ATTACHMENT 1
NRC DOCKET 50-321
OPERATING LICENSE DRP-57
EDWIN I. HATCH NUCLEAR PLANT UNIT 1
RADIOLOGICAL EFFLUENT TECHNICAL SPECIFICATIONS

The proposed change to the Technical Specifications (Appendix A to the Operating License) would be incorporated as follows:

ATTACHMENT 2
NRC DOCKET 50-366
OPERATING LICENSE NPF-5
EDWIN I. HATCH NUCLEAR PLANT UNIT 2
RADIOLOGICAL EFFLUENT TECHNICAL SPECIFICATIONS

FIGURE 3.15-1 UNRESTRICTED AREA BOUNDARY

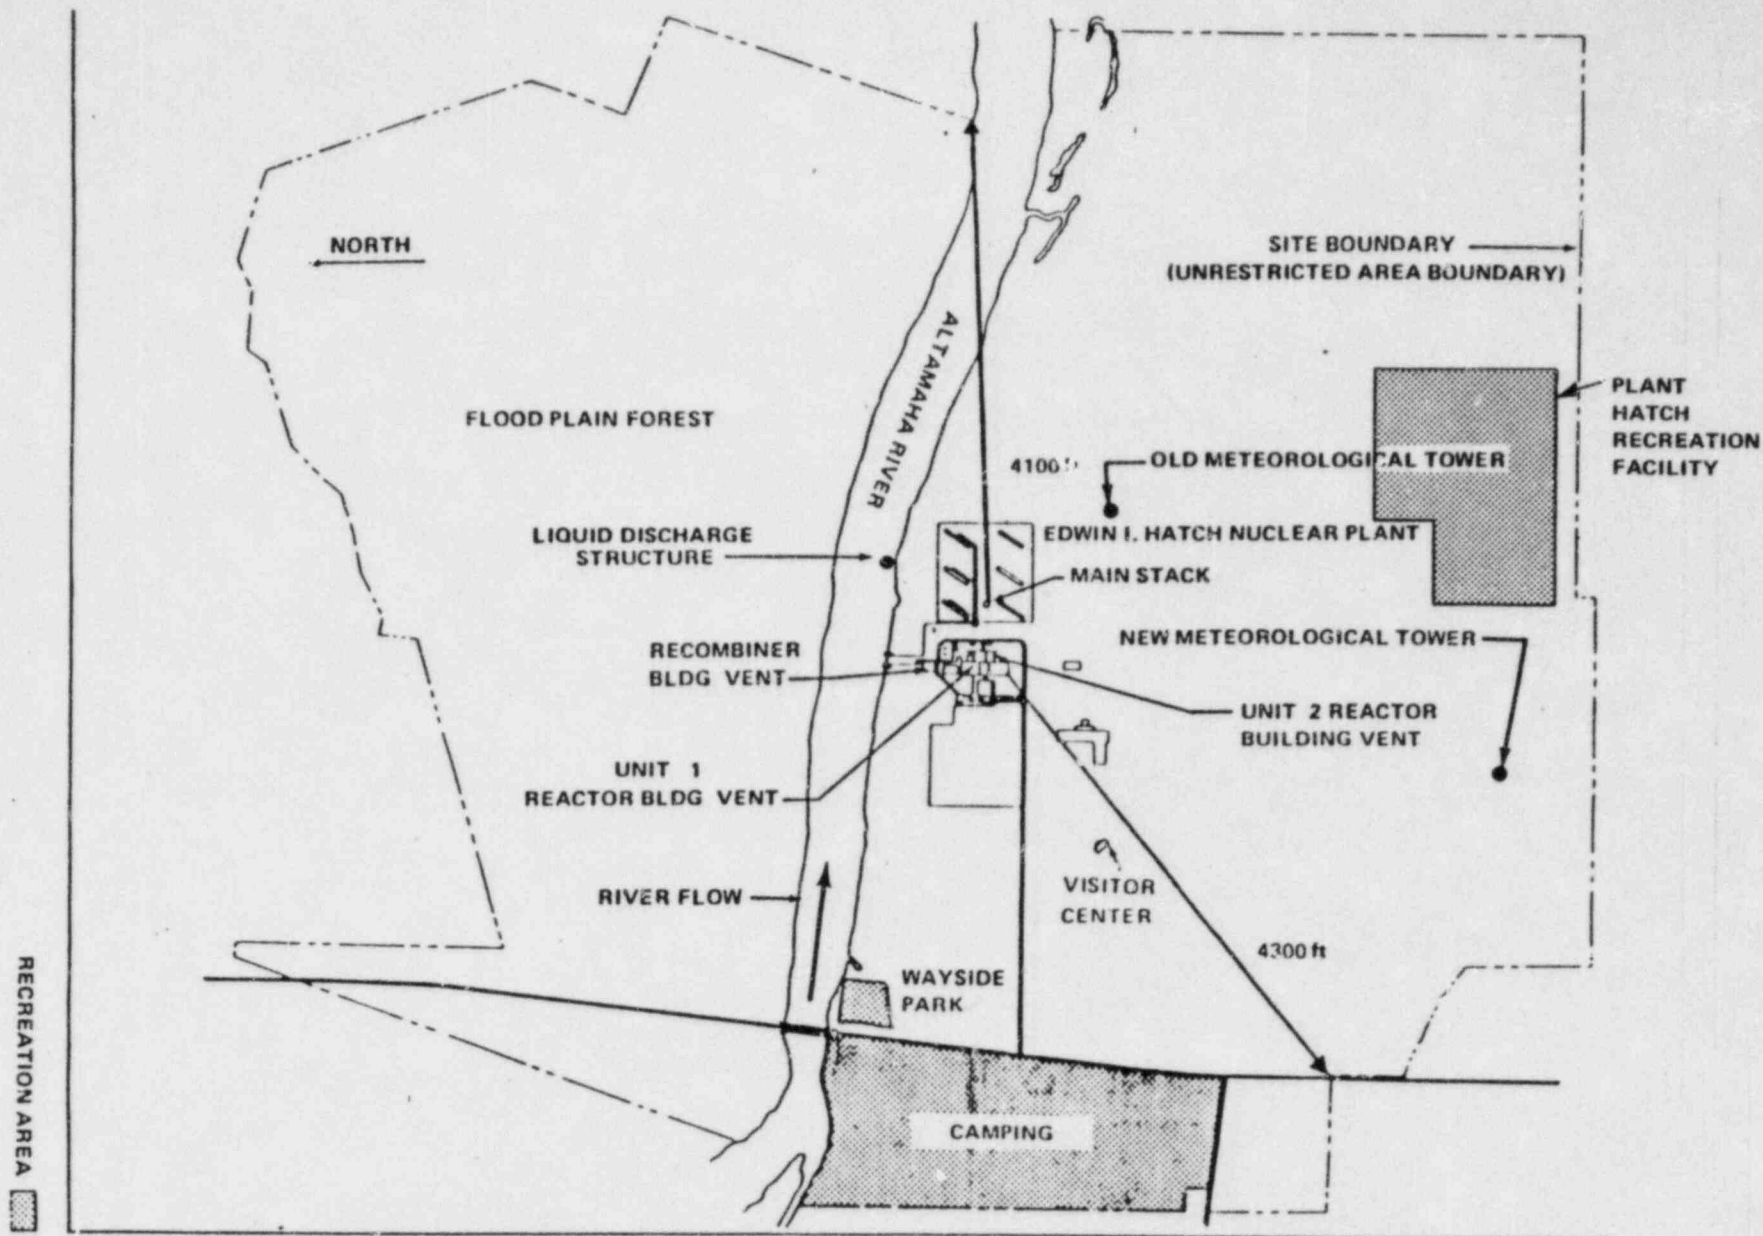
The SITE BOUNDARY shall be that line beyond which the land is not owned, based, or otherwise controlled by Georgia Power Company, as shown in figure 3.15-1.

3.15.1.1 The concentration of radioactive material released at any time from the site to UNRESTRICTED AREAS (figure 3.15-1) shall be limited to the concentrations specified in 10 CFR Part 20, Appendix B, Table II (column 2) for radionuclides other than dissolved or entrained noble gases. For dissolved or entrained noble gases, the concentration shall be limited to 2×10^{-4} $\mu\text{Ci/ml}$ total activity.

3.15.1.2 The dose or dose commitment to a MEMBER OF THE PUBLIC from radioactive materials in liquid effluents released, from each reactor unit, from the site (figure 3.15-1) shall be limited to:

3.15.2.1 The dose rate at any time in the UNRESTRICTED AREAS (figure 3.15-1) due to radioactive materials released in gaseous effluents from the site shall be limited to the following values:

FIGURE 3.11-1 UNRESTRICTED AREA BOUNDARY

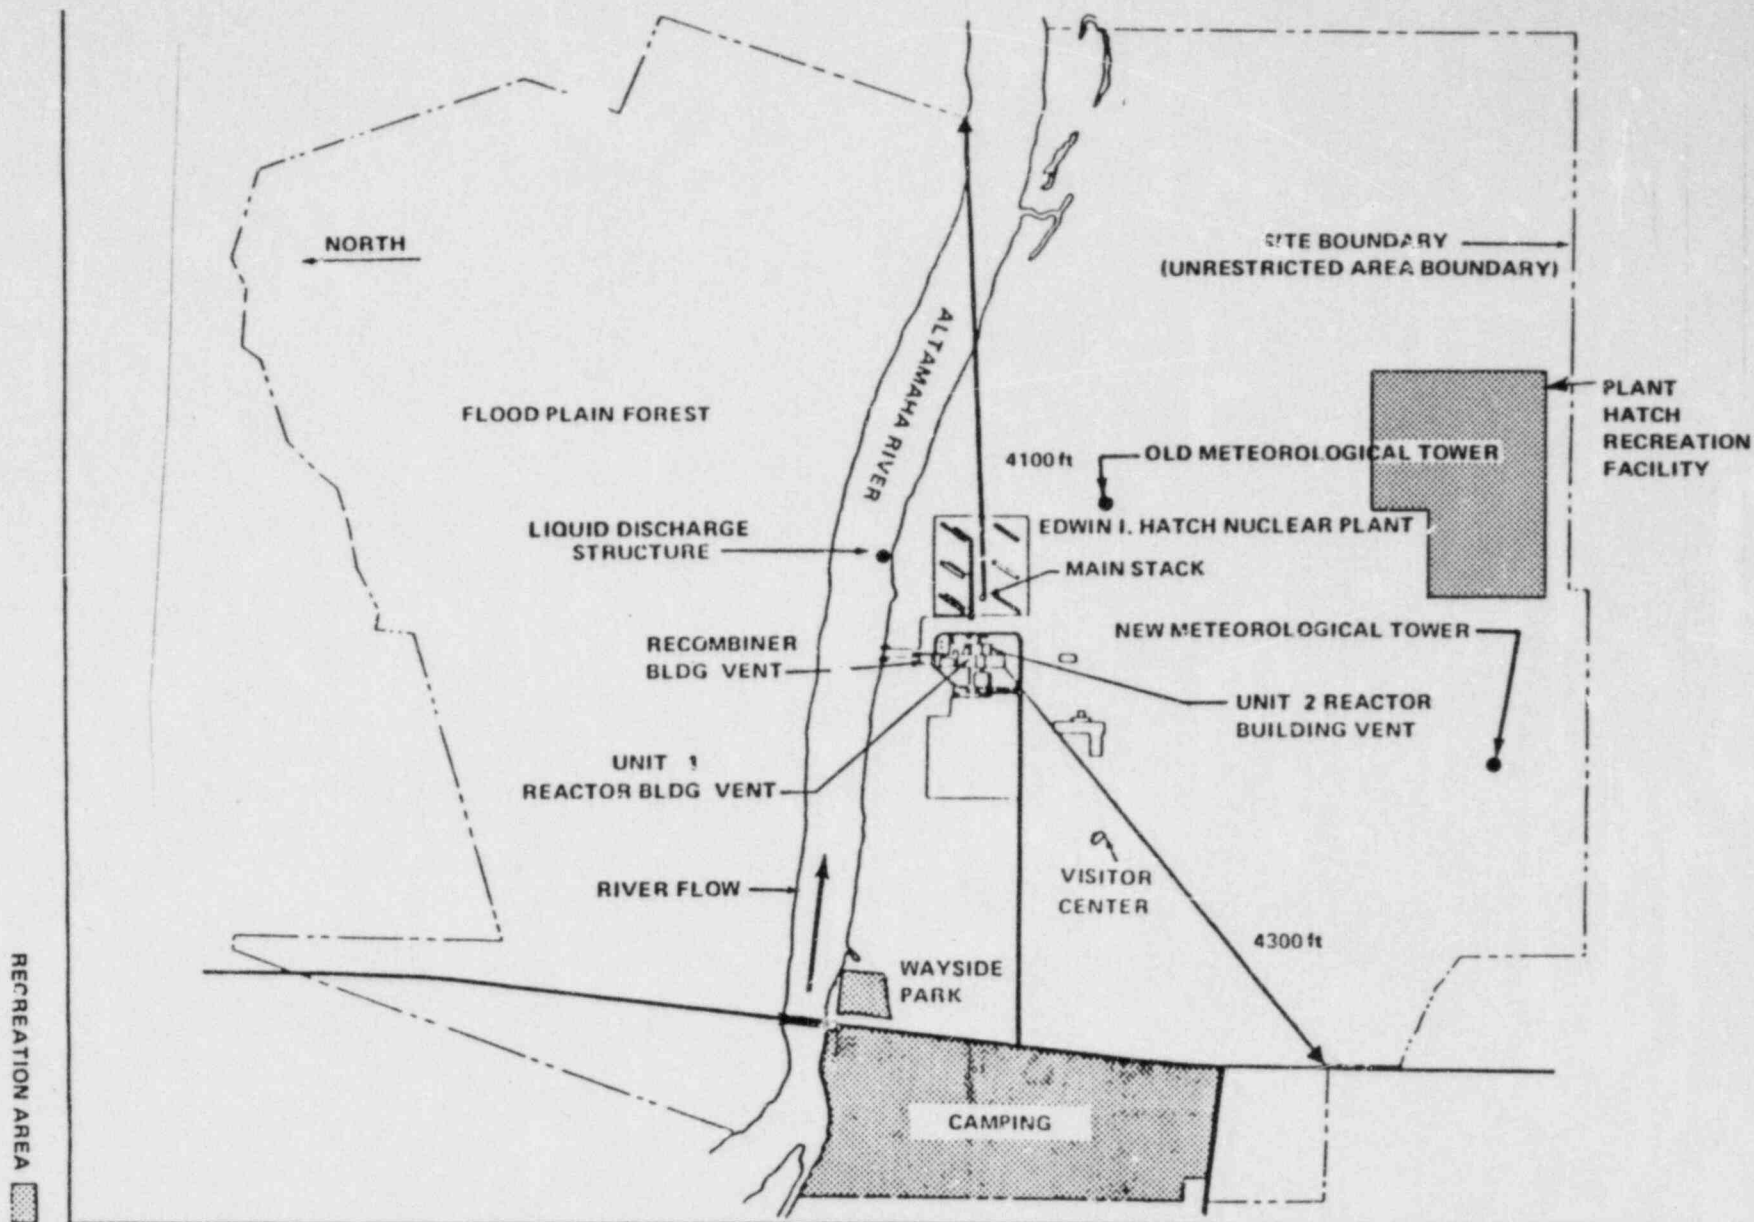
The SITE BOUNDARY shall be that line beyond which the land is not owned, leased, or otherwise controlled by Georgia Power Company, as shown in figure 3.11-1.

3.11.1.1 The concentration of radioactive material released at any time from the site to UNRESTRICTED AREAS (figure 3.11-1) shall be limited to the concentrations specified in 10 CFR Part 20, Appendix B, Table II (column 2) for radionuclides other than dissolved or entrained noble gases. For dissolved or entrained noble gases, the concentration shall be limited to 2×10^{-4} $\mu\text{Ci/ml}$ total activity.

3.11.1.2 The dose or dose commitment to a MEMBER OF THE PUBLIC from radioactive materials in liquid effluents released, from each reactor unit, from the site (figure 3.11-1) shall be limited to:

3.11.2.1 The dose rate at any time in the UNRESTRICTED AREAS (figure 3.11-1) due to radioactive materials released in gaseous effluents from the site shall be limited to the following values:
